Williamsburg-James City County School Division
Invitation for Bids (IFB) # 20230938
Clara Byrd Baker Elementary School Restroom Renovations

ADDENDUM NO. 1

This Addendum provides answers to vendor questions and the sign-in sheet from the Pre-Bid Conference.

DETAIL F122

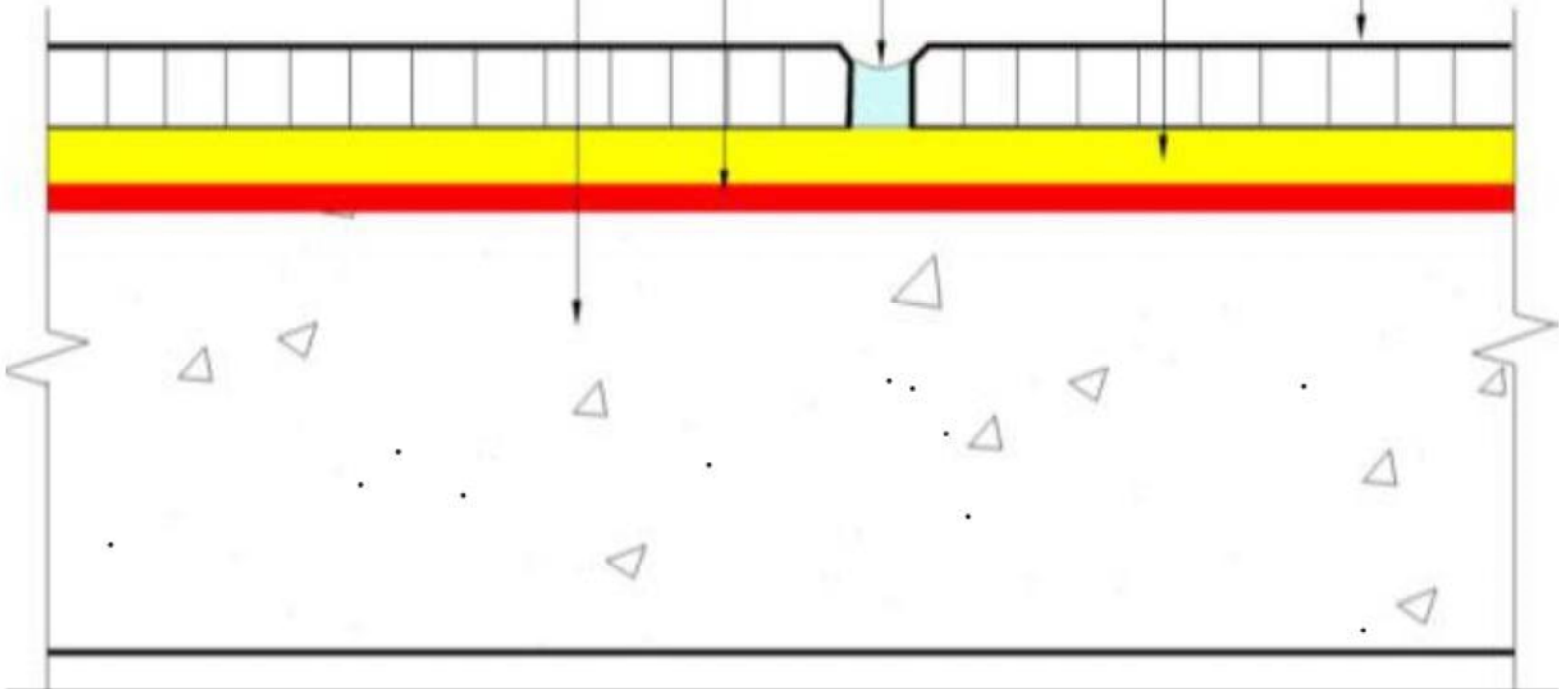
15. Please provide a detail for any waterproofing/vapor emission requirements for the new tile that is to be installed on existing CMU. Please note that most manufacturers require a detail of furring and tile backer board installed on the existing CMU.

ANSWER: Revise Section 093000, 3.7 to read as follows:

3.7 INTERIOR CERAMIC TILE INSTALLATION SCHEDULE

A. Interior floor Installations, Concrete Subfloor

1. Ceramic Tile Installation: *TCNA F122 and F122A; waterproofing membrane; thinset mortar; epoxy grout.*

a. Thinset Mortar: Modified dry-set mortar.

b. Grout: Water-cleanable epoxy grout.

See attached Detail F122.
